Project	IEEE 802.16 Broadband Wireless Access Working Group < http://ieee802.org/16 >	
Title	Optimized Distributed Bandwidth Request and Allocation in 802.16j system	
Date Submitted	2007-05-09	
Source(s)	<p>Shulan Feng, Yanling Lu, Ting Li, Liangliang Zhang Hisilicon Technologies Harbour Building, No.8, Dongbeiwang West Road, HaiDian District, Beijing, China</p> <p>Masato Okuda and Yuefeng Zhou Fujitsu</p> <p>Kanchei (Ken) Loa, Yi-Hsueh Tsai, Yung-Ting Lee Institute for Information Industry 8F., No. 218, Sec. 2, Dunhua S. Rd., Taipei City, Taiwan</p>	<p>Voice: 86-10-82829010 Fax: 86-10-82829075 mailto:luyanling@hisilicon.com, fengsl@huawei.com</p> <p>mailto:okuda@jp.fujitsu.com Yuefeng.Zhou@uk.fujitsu.com</p> <p>Voice: +886-2-2739-9616 E-mail: loa@iii.org.tw</p>
Re:	This contribution is a response to "IEEE 802.16j-07/013 Call for Technical Comments regarding IEEE Project 802.16j" (2007-04-02).

Distributed Scheduling In 802.16j System

Figure 1 Periodic Bandwidth Grant with RS_SCH_IE

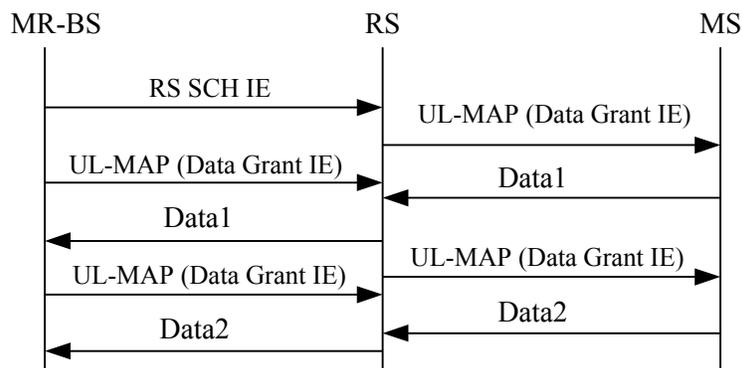
In MR system with distributed scheduling, the MR-BS or a RS may send its RS_SCH_IE in advance to its subordinate RS, to indicate when and how much bandwidth it will schedule for the real time service in the future. The RS_SCH_IE includes the CID on which the user traffic is carried, the frame offset to indicate when the bandwidth will be granted and the size of bandwidth allocation. The actual grant is issued using Data Grant IE as defined for single hop case. For periodical bandwidth grant, RS_SCH_IE could be sent just once.

RS_SCH_IE is generated by the MR-BS or a RS and sent to its subordinate RS until the MS's access station is reached. Figure 1 illustrates the bandwidth grant procedure using RS_SCH_IE.

Figure 2 Periodic Polling with RS_SCH_IE

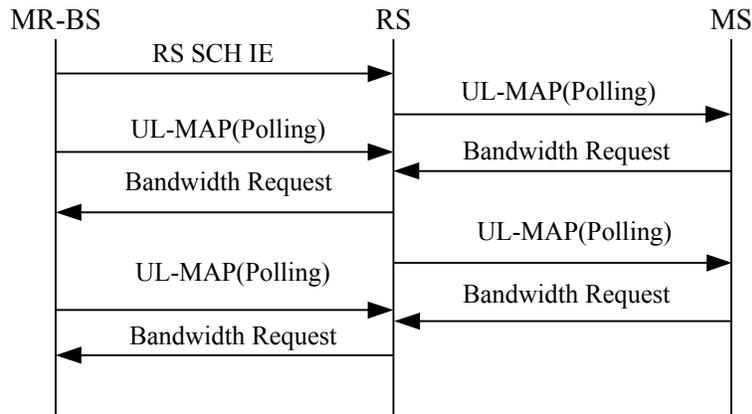
Similar to the bandwidth grant, the periodic polls issued by the MR-BS or a RS to its subordinate RS may be accompanied with a RS_SCH_IE. The RS-SCH-IE is generated by the MR-BS or a RS and sent to its subordinate RS until the access RS is reached. Figure 2 illustrates the polling procedure using RS_SCH_IE.
